**TYPE III –Master Plan and Detailed Development Plan
SUPPLEMENTAL FINDINGS FOR ADDITIONAL ADJUSTMENTS
STAFF REPORT AND RECOMMENDATION**

September 1, 2017

FILE NUMBER: CP-17-0002: General Development (Concept) Plan
DP-17-0003: Detailed Development Plan for Phase 1
NR-17-0004: Natural Resource Overlay District Verification

Approval for General Development Plan for Abernethy Place, a mixed-use project including Hotel, Multi-Family, Retail/Commercial and Office Use to be constructed in two phases over 10-years as well as a Detailed Development Plan for Phase 1 which includes construction of a Hotel and parking lots.

LOBBY FLOOR

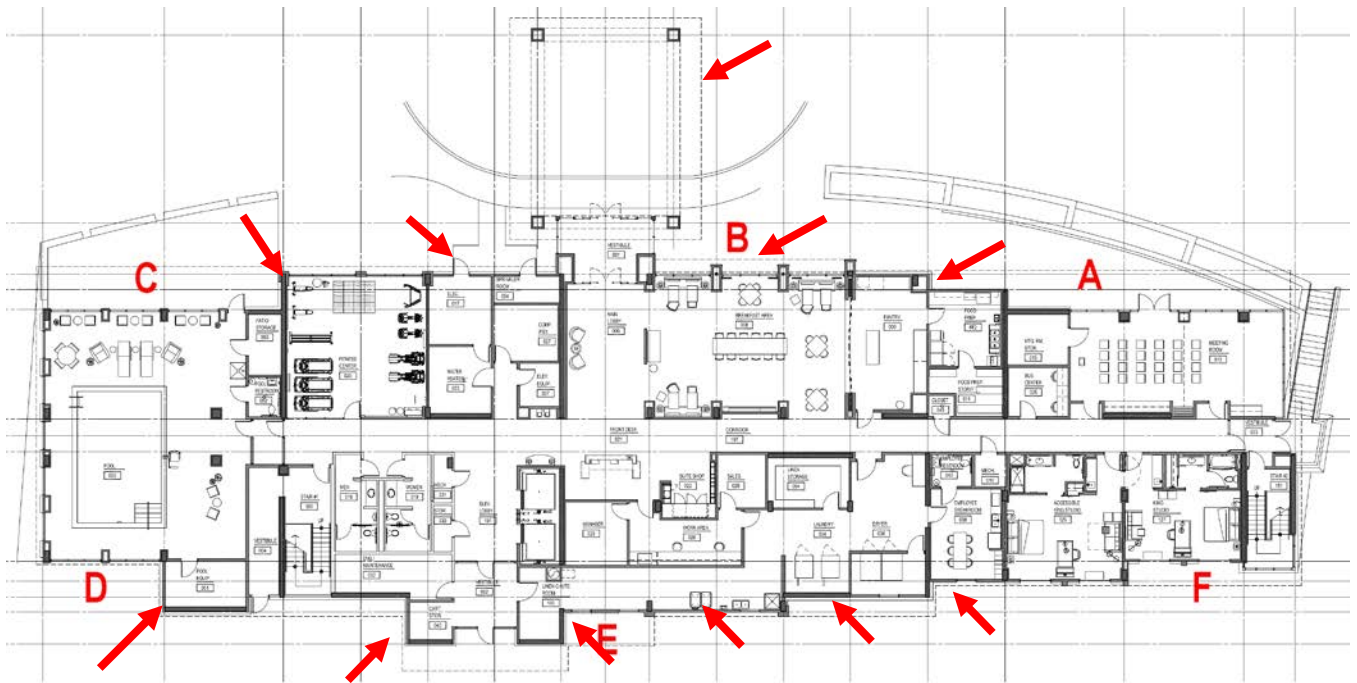
North Facade: At the lobby level, the large windows located at 'A' and 'C' are recessed approximately 7.23 feet back from the wall plane located at 'B' meeting the depth standard. The recessed wall at 'A' is approximately 55

feet long, and 'C' is approximately 45 feet long. At the top of the building the face of the wall and parapet are recessed between 7.7 feet and 11.5 feet back from the face of the parapet at the center of the building, a distance of approximately 68 feet, which meets the standard. At floors 2 thru 5 the wall planes located at 'G' and 'I' are recessed approximately 6.8 feet back from the wall plane at 'H' [a recess of 2.8%] for a length of 56 feet and 45.5 feet respectively. Additional recesses also occur at several locations [see arrows], further adding to visual relief of the facade.

South Façade: At the ground level, the wall planes located at 'D' and 'F' are recessed approximately 9.5 feet back from the wall plane located at 'E', meeting the depth standard. The recessed wall at 'D' is approximately 23 feet long, and 'F' is approximately 33 feet for a total of approximately 56 feet, which meets the standard. At the top of the building the face of the wall and parapet are recessed between 7.7 feet and 11.5 feet back from the face of the parapet at the center of the building, a distance of approximately 68 feet, which meets the standard.

Finding: Complies as proposed. In addition to the purpose of the MUD District, the purpose of the requirement is to allow for visual interest and provide visual relief by breaking up the massing of a large wall into smaller segments. As described by the applicant, the adjustment is proposed for floors 2 thru 5. The applicant has met the intent of the standard by providing more than the minimum length of the articulation and by offsetting the articulation. In addition, the proposed design includes a variety of building materials, windows, and landscaping which create the same overall effect of providing visual relief and deconstructing a large building into smaller segments. The applicant's description of the proposed adjustment #5 to reduce the depth of required wall plane projections or recesses from three percent to 2.8 percent, and further clarify that multiple projections or recesses have been added to achieve the required percentage overall on the various facades has adequately addressed the purposes of the MUD zone.

FLOORS 2 thru 5

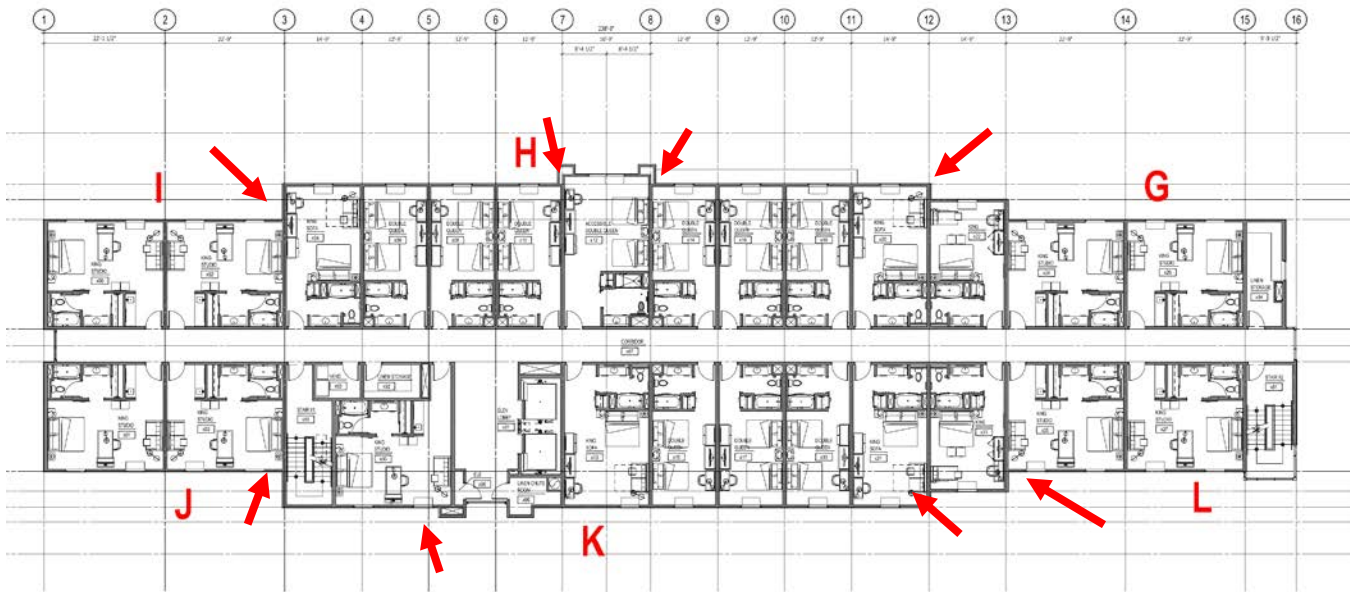
At floors 2 thru 5 the wall planes located at 'L' and 'J' are recessed approximately 6.8 feet back from the wall plane at 'K' [a recess of 2.8%] for a length of 56 feet and 45.5 feet respectively. Additional recesses also occur at several locations [see arrows], further adding to visual relief of the facade.

The proposed design provides building articulation at the parapet which exceeds the requirements of the code. This parapet articulation will be the most visible when the building is viewed either from a distance or from pedestrians in close proximity to the building. The proposed design also provides building articulation at the ground level which exceeds the requirements of the code. This ground level articulation will be most visible to pedestrians when they are in close proximity to the building. Finally the proposed design provides articulation at floors 2 through 5 which is within a few inches of complying with the standard. The articulation at floors 2 through 5 will be difficult for people viewing the building to perceive since it cannot be judged at either the ground level or at the parapet, and it is difficult to assess the depth of the articulation of these floors when viewed either from a distance or from close proximity to the building. Furthermore the design includes additional architectural features which, although they do not technically comply with the design standard, add depth and interest to floors 2 through 5.

Finding: Complies as Proposed. The standard requires a projection or recess of 3% of 238 feet or 7.14' for a minimum length of 20% of the length of the façade, or 47.6 feet. This standard could met by providing a single recess of the required depth and length on all building walls. Instead, the applicant's proposal for floors 2 thru 5 the wall planes located at 'L' and 'J' are recessed approximately 6.8 feet back from the wall plane at 'K' [a recess of 2.8%] for a length of 56 feet and 45.5 feet respectively. Additional recesses also occur at several locations [see arrows], further adding to visual relief of the facade.

There are in total 7 changes in plane varying in length from 14' long to 52' long on floors 2 through 5. Therefore, while the depth of any single articulation does not meet the full 3% depth for 20% of the length in all cases, the cumulative effect of these additional articulations is provided at all floors. Furthermore, the applicant has proposed to exceed the minimum 30% transparency requirement on the North side façade at the pedestrian level with 42% transparency. Multiple building material texture changes consisting of wood texture, fiber cement panels, smooth plaster, and architectural metal have been proposed. Four rows of 18 windows per floor are proposed on floors 2 through 5 on both the North and South facades. Cumulatively, these design aspects adequately mitigate for the adjustment.
